Technical Service Bulletin

SUBJECT:			No: TSB-21-52A-002REV
EXCESSIVE INTERMITTENT MOVEMENT IN DRIVER'S POWER SEAT - REVISED			DATE: March 2023
			MODEL: 2007-19 Outlander, 2018-19 Outlander PHEV, 2011-21 Outlander Sport/RVR
CIRCULATE TO:	<input type="checkbox"/> GENERAL MANAGER	<input checked="" type="checkbox"/> PARTS MANAGER	<input checked="" type="checkbox"/> TECHNICIAN
<input checked="" type="checkbox"/> SERVICE ADVISOR	<input checked="" type="checkbox"/> SERVICE MANAGER	<input checked="" type="checkbox"/> WARRANTY PROCESSOR	<input type="checkbox"/> SALES MANAGER

This bulletin supersedes TSB-21-52A-002REV, issued October 2021 and updates the affected vehicles and ending VIN numbers. Revisions are italicized and indicated by ◀.

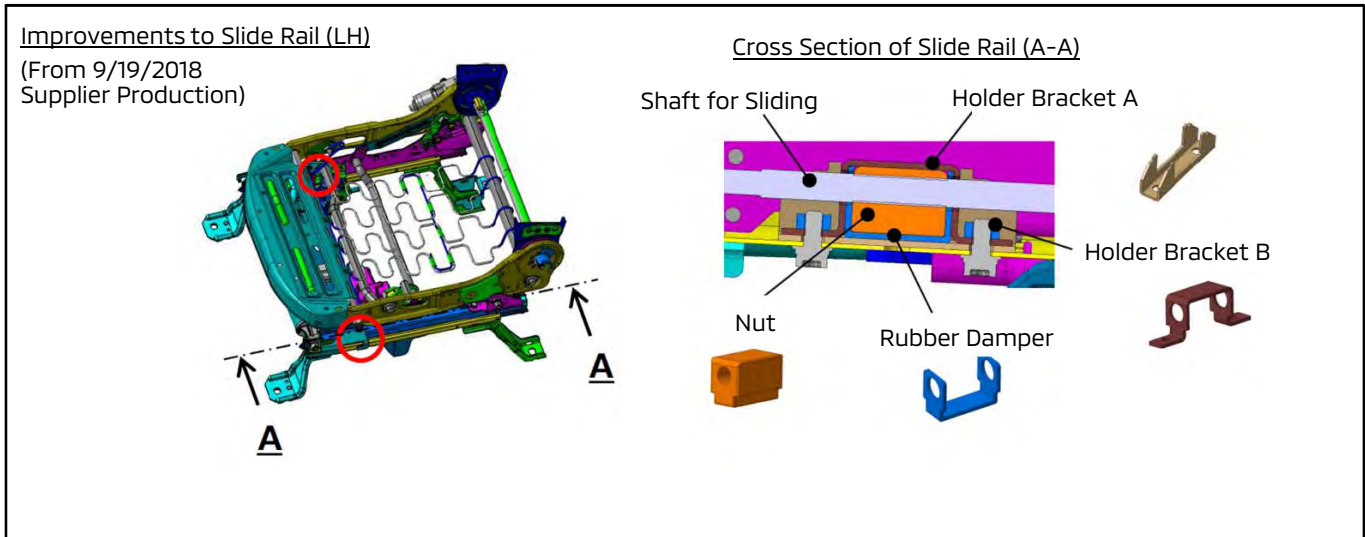
Height adjustment linkages in the seat adjuster assembly may loosen over time with normal driving and allow movement. A new seat adjuster was implemented in production at the supplier from March 2, 2016, and has added metal bushings at the 6 rotational connections on the seat frame, as shown below.

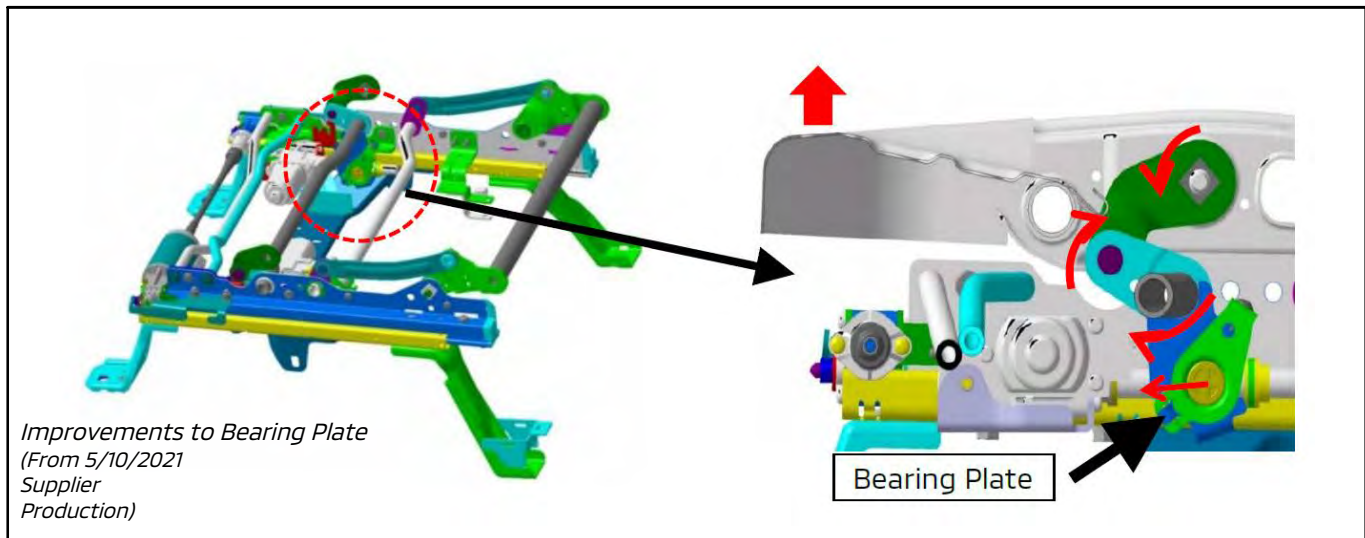
The clearance of the slide rail and rubber damper has also been changed in production at the supplier starting September 19, 2018. Refer to the VINs listed in Affected Vehicles.
